## Technical Service Bulletin

### MODEL(S) T581 Rider Floor Scrubber

**SUBJECT:** Potential propel power failure due to faulty wire harness connection.  
Small red wire pulling out of battery cable connector due to stress on wires.

### Faulty Wire Harness Connection

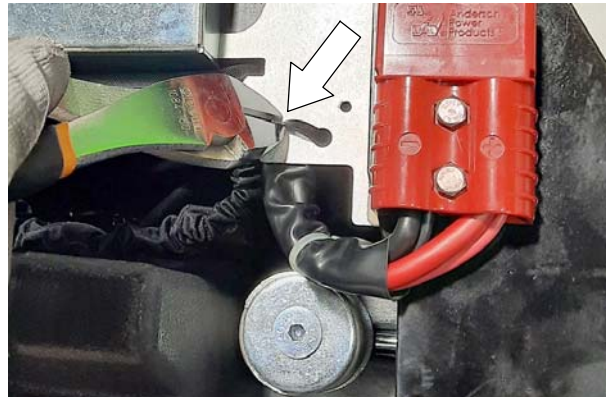
1. Inspect wire connection below. If wires are stressed, adjust harness as described.
2. If wire is pulled out or loose, repair connection and adjust harness to relieve stress on wires.
3. Replace connectors as needed.

1. Cut cable-tie securing wire harness.
2. Adjust harness to relieve stress on wires as shown below.
3. Resecure wire harness with new cable-tie.
